Council Ref: SSD 8517 & SSD 8449 MOD 1

RESPONSE TO SUBMISSIONS SSD 8517 & SSD 8449 – MOD 1 LOCOMOTIVE WORKSHOP, SOUTH EVELIEIGH

Figure 1 Extract of City of Sydney's Water Assets database

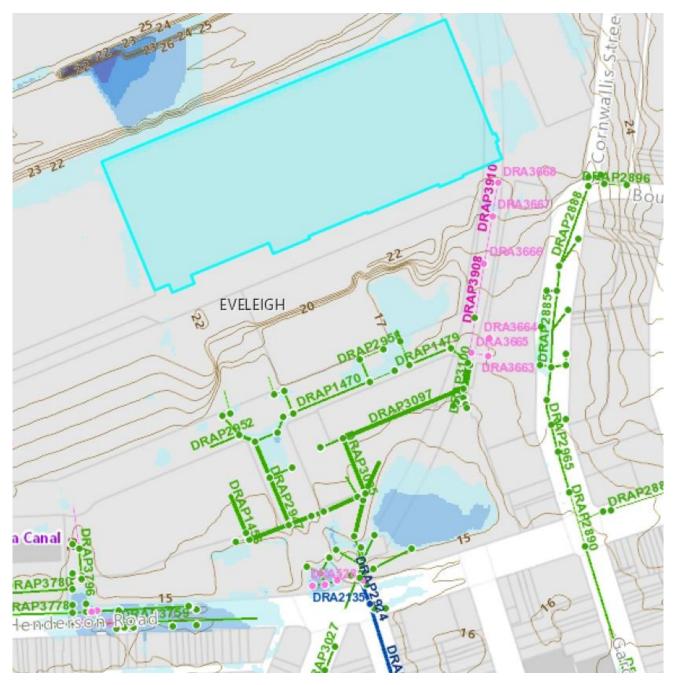
Copies of relevant email correspondence from Council is included at **Attachment A**. Within this additional correspondence, whilst Council acknowledge (in the email dated 24 May 2019) that the pollutant load reduction targets specified in section 3.7.3 of DCP 2012 do not apply to the development, Council are not willing to alter their opinion, noting that "The site drainage connects to a series of Council controlled stormwater pipes (to be handed to Council in future) prior to connecting to Sydney Water storm water assets".

In referring to the site drainage system being connected to Council controlled stormwater pipes, we would like to clarify that the stormwater pipes are currently privately owned and controlled by Mirvac. They are not to be handed to Council for another 27 years. Notwithstanding this, as shown in **Figure 1**, the Mirvac owned stormwater pipes (shown in Green) are an isolated system that all drain into the Sydney Water asset (shown in Blue). Accordingly, we do not see that there are any impacts generated (either on-site or off-site) by not meeting the targets currently outlined in Conditions B29 and B25. Particularly when the Mirvac owned stormwater pipes all connect to the Sydney Water Asset, and Sydney Water has no objection to the proposed modification, as explained in Section 2.0.
